**REPORT OF ALTERATIONS TO DESIGNATED RESOURCE**  
**Site Number/Address: 421 Mathews Street**  
**Laurel School National Register Historic District**  
**ISSUED: February 17, 2021**

This report is to document the summary of effects from proposed alterations to the Tomlin-Roberts Residence at 421 Mathews Street, pursuant to Fort Collins Municipal Code Chapter 14, [Article IV](#), made by the Landmark Preservation Commission at their February 17, 2021 meeting. A copy of this report may be forwarded to the Colorado Office of Archaeology and Historic Preservation.

# McCarty Remodel

**McCarty Remodel**  
421 Mathews St.,  
Fort Collins, CO

Elevations

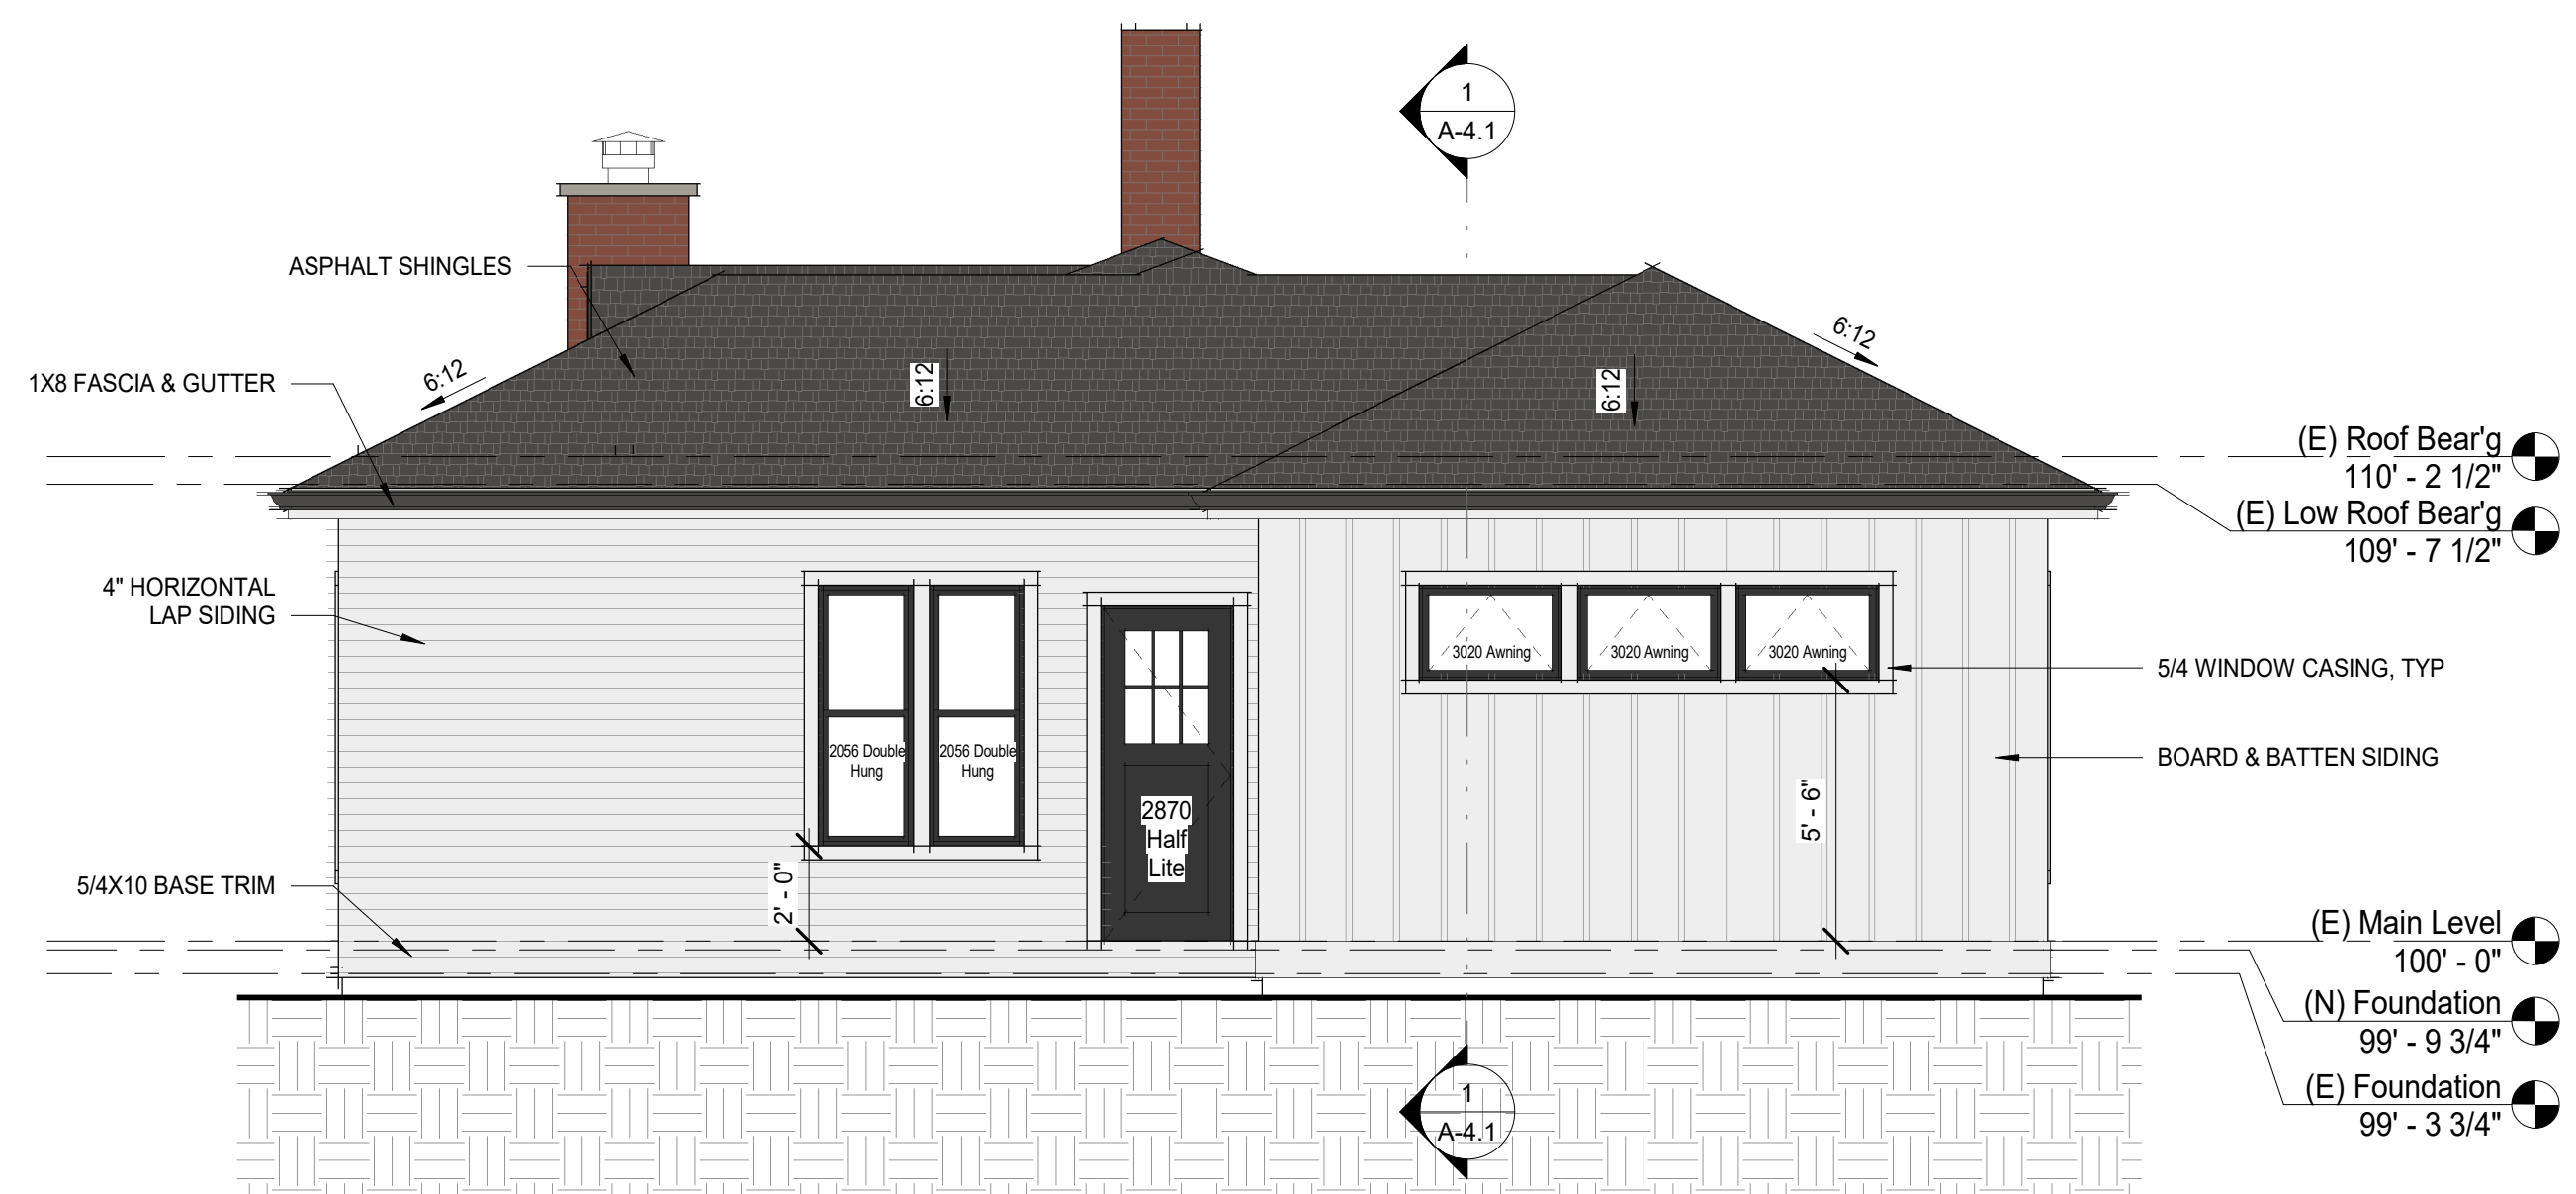
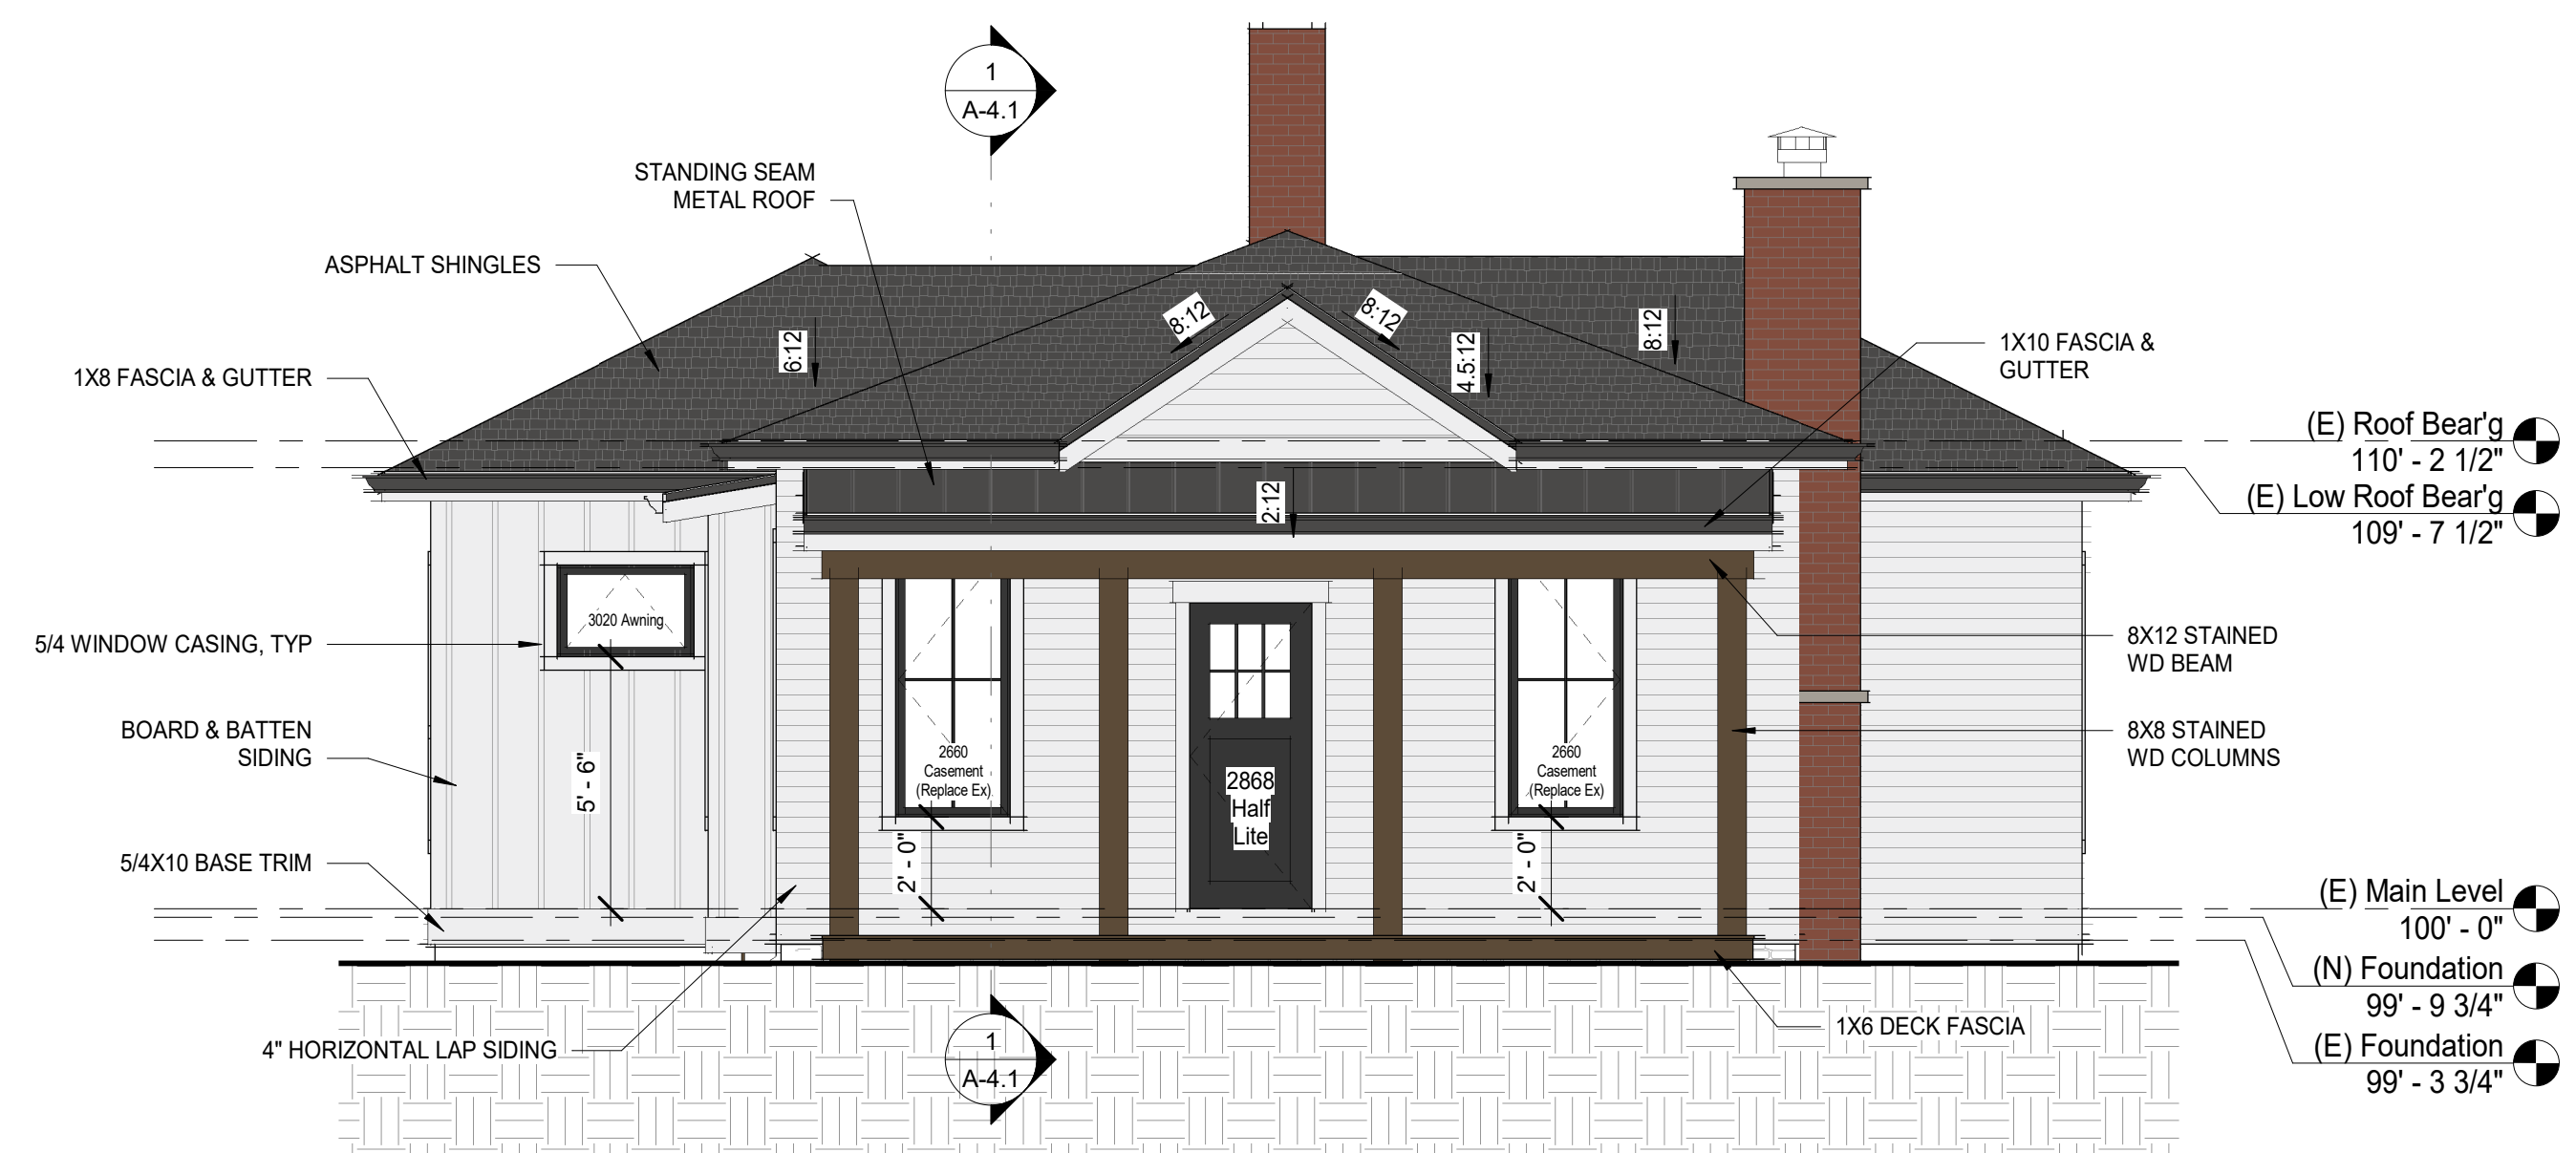
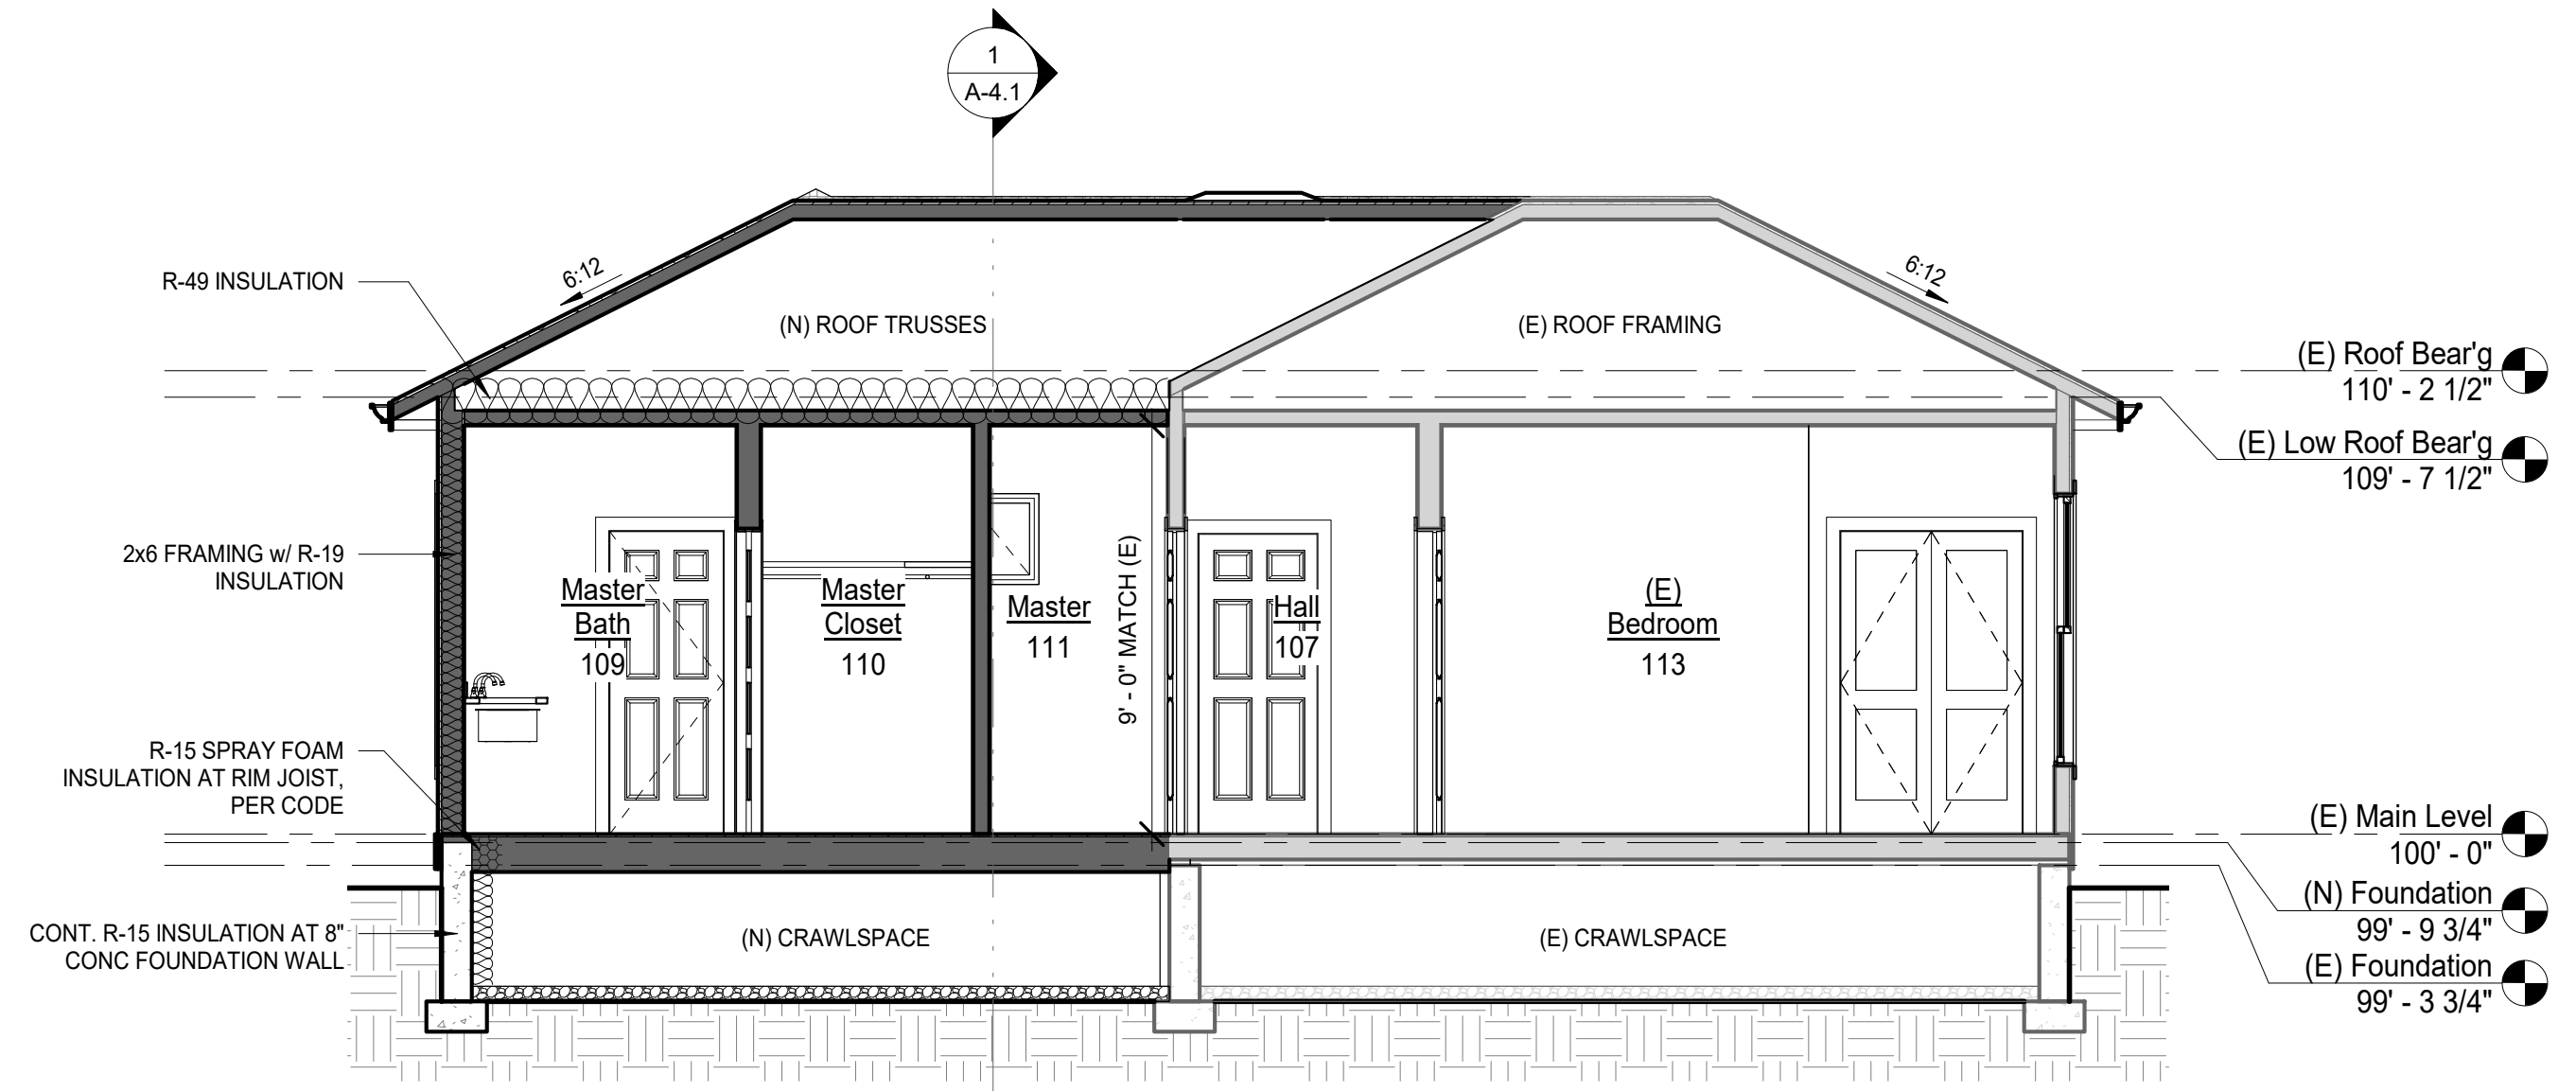
<p>4. South bay window replacement</p> <p>a. <i>The project will remove the distinctive canted bay window on the south elevation and replace it with a boxed bay window. This is a character-defining feature and its removal does not meet this Standard.</i></p> <p>5. Front porch replacement</p> <p>a. <i>The history of the front porch is unclear based on primary source documents, however, the existing front porch is compatible with the overall Edwardian/Victorian character of the house. The new proposed front porch removes the entire structure, replaces the lathe-turned posts with squared posts, and replaces the tongue-and-groove decking and reconfigures the decking from perpendicular to parallel with the façade, ultimately resulting in a porch that is not characteristic of this style of house. This project element does not meet this Standard.</i></p> <p>6. Reconstruction of the brick chimneys</p> <p>a. <i>Due to deterioration, the brick chimneys require deconstruction and reconstruction to ensure suitable mortar joints. This is a common repair to neglected masonry chimneys. However, the reconstruction of the prominent chimney on the north elevation is not in-kind and introduces a non-historic stone cap rather than reconstructing to match the existing configuration. This element does not meet this Standard.</i></p> <p>7. Demolition of shed at southwest corner of lot</p> <p>a. <i>This shed does not appear on any Sanborn maps through 1943 and may have been salvaged and moved to the property at a later date. It is not considered an historic resource for the purposes of this review.</i></p>

- Are the exterior window surrounds being removed, and if so why? of window surrounds on exterior

I will be reusing the Window Surrounds minus the ones at the front windows due to the install of the front porch that were cut down to fit the front porch. I will have to replace the top trim piece as shown on photos 1 and 2.
